SERVICE DIRECTIVE BULLETIN NO. 0093

Revision 1

1. SUBJECT: Tail Rotor Control Cable Inspection
2. MODEL: F-28A, F-28C(-2), F-28F, 280, 280C, 280F, and 280FX
3. EFFECTIVITY: All serial numbers equipped with tail rotor control cable pulleys installed in the tailcone (Refer to paragraph 4)
4. BACKGROUND:

Figure 1. Tail Rotor Control Cable Pulley Installation

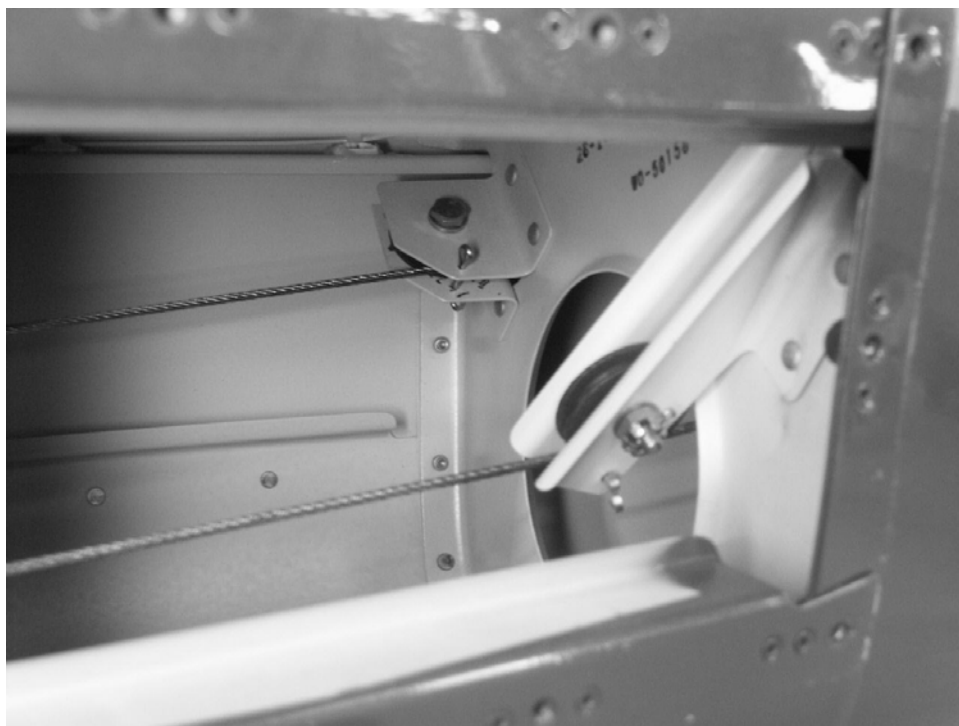
Enstrom has received reports from inspection personnel in the field of frayed and worn tail rotor control cables. The reports indicate that the wear is occurring at the pulleys (See Figure 1) in the tailcone located aft of the horizontal stabilizers. These pulleys are installed in tailcone assemblies installed on all 280FX model aircraft and F-28F model aircraft, S/N 744 and subsequent.

Figure 1 shows the latest tail rotor control cable pulley installation. On earlier installations, the left side pulley installation is a mirror image of the right side pulley installation.

4. Partially pull the tail rotor control cables out of the tailcone through the access opening and inspect the areas of the tail rotor control cables that pass over the pulleys and inspect the pulleys in accordance with FAA Advisory Circular 43.13-1B, paragraph 7-149, Cable System Inspection (Appendix A to this Service Directive Bulletin). If the pulleys are rubbing on the mounting brackets, AN960-10L Washers may be used as shims to eliminate the interference.

5. Replace/Reinstall the tail rotor control cables and/or pulleys as required. Set the control cable tension and tail rotor rigging in accordance with the maintenance manual.

Figure 2. Access Panel Location

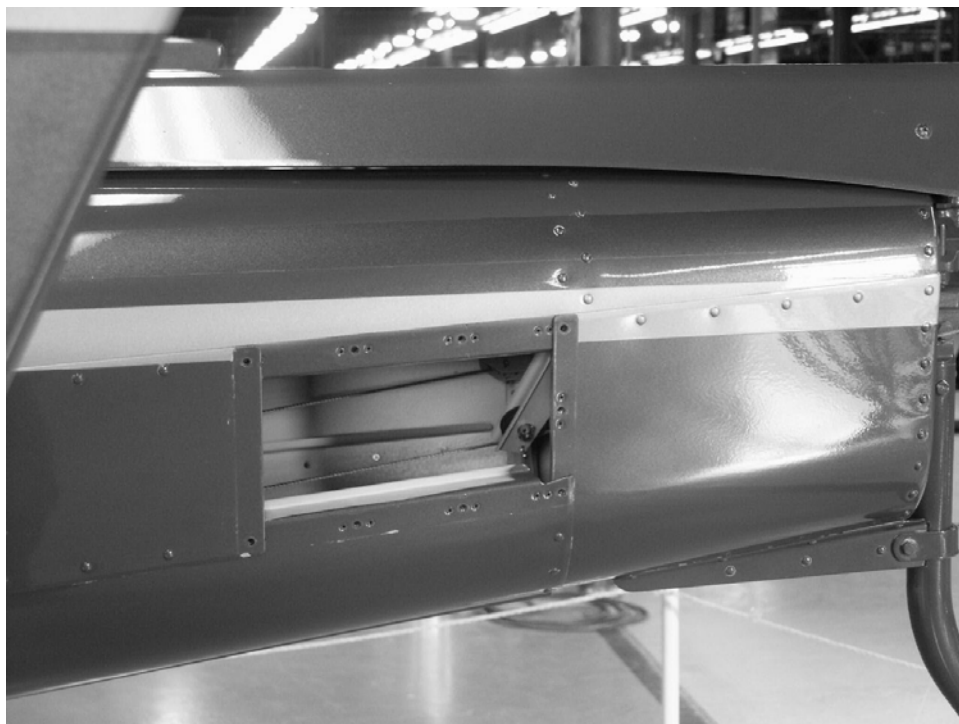
1. Remove the access panel located aft of the horizontal stabilizer on the left side of the tailcone (See Figure 2) and determine if the tailcone is equipped with the pulleys.
